SOLICITATION AMENDMENT
MODIFICATION DE L'INVITATION

Title - Sujet Lab Exhaust System Alteration	
Solicitation No. - N° de l'invitation EZ899-141333/A	Amendment No. - N° modif. 007
Client Reference No. - N° de référence du client	Date 2014-01-08
GETS Reference No. - N° de référence de SEAG PW-\$PWY-004-7132	
File No. - N° de dossier PWY-3-36145 (004)	CCC No./N° CCC - FMS No./N° VME
Solicitation Closes - L'invitation prend fin at - à 02:00 PM on - le 2014-01-14	Time Zone Fuseau horaire Pacific Daylight Saving Time PDT
F.O.B. - F.A.B. Plant-Usine: <input type="checkbox"/> Destination: <input checked="" type="checkbox"/> Other-Autre: <input type="checkbox"/>	
Address Enquiries to: - Adresser toutes questions à: Mestry, Ruth (PWY)	Buyer Id - Id de l'acheteur pwy004
Telephone No. - N° de téléphone (604) 775-9385 ()	FAX No. - N° de FAX (604) 775-6633
Destination - of Goods, Services, and Construction: Destination - des biens, services et construction: AAFC - Pacific Agri-Food Research Centre - Summerland, BC

Attached is Addendum No.3

- .1 Refer to electrical addendum E02, prepared by Stantec Consulting Ltd., dated January 8, 2014, appended to this Addendum, (17 pages).

PARTIAL POWER SINGLE LINE DIAGRAM

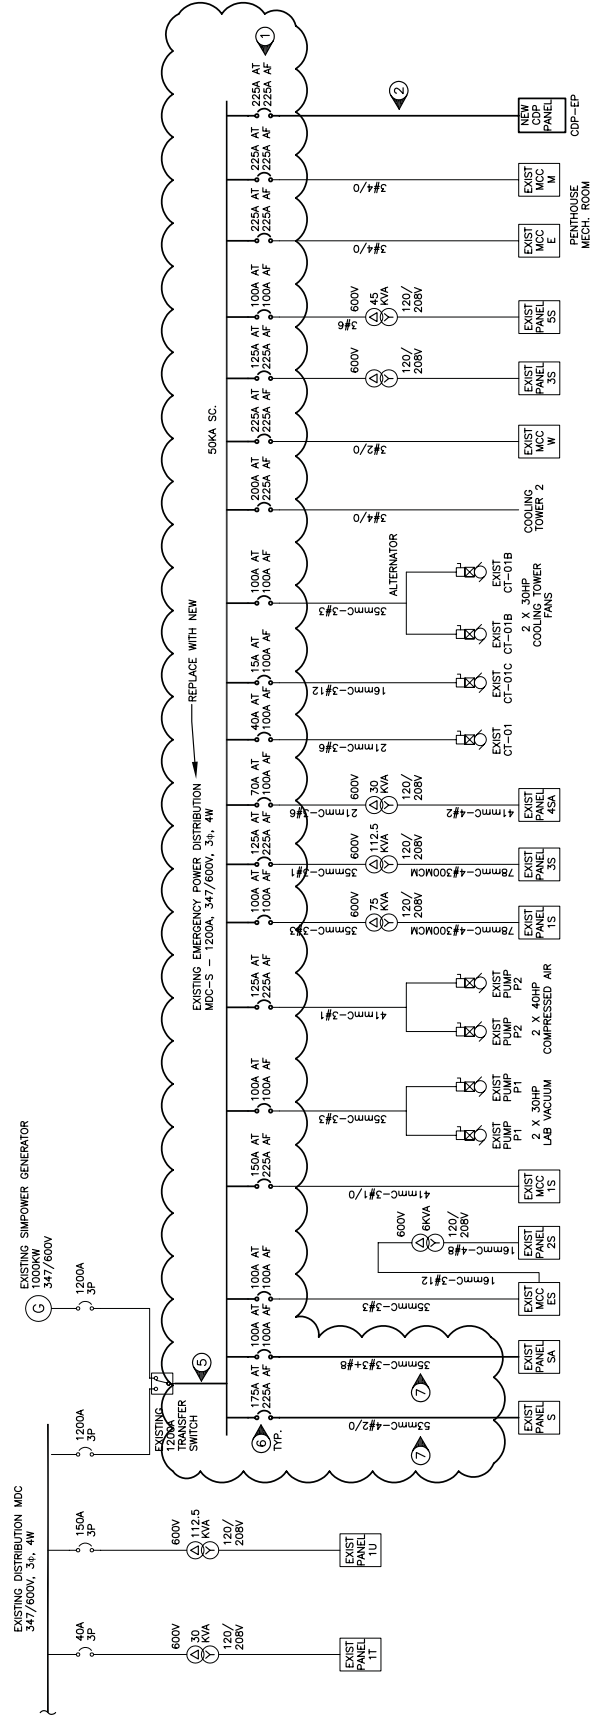
- .5 Power Single Line diagram
 - (1) **Revise** power single line diagram as shown on attached **sketch ESK-002** and **add** keynotes #5 to #7 as shown.

- 4 THE ADDITION OF NEW BREAKER IN MDC-S TO BE PERFORMED AFTER NORMAL WORKING HOURS. THE ADDITION OF NEW BREAKER SHALL BE COMPLETED WITHIN 2 WEEKS PRIOR TO WORK.
- 5 REPLACE EXISTING POWER FEEDER FROM TRANSFER SWITCH TO NEW MDC-S WITH 4XNEW 4/300CMC.
- 6 REPLACE ALL EXISTING BREAKERS IN MDC-S WITH NEW BREAKERS RATED MINIMUM 35KA S.C.C. RATING.
- 7 REPLACE EXISTING POWER FEEDERS WITH NEW CONDUIT AND WIRING TO NEW MDC-S.
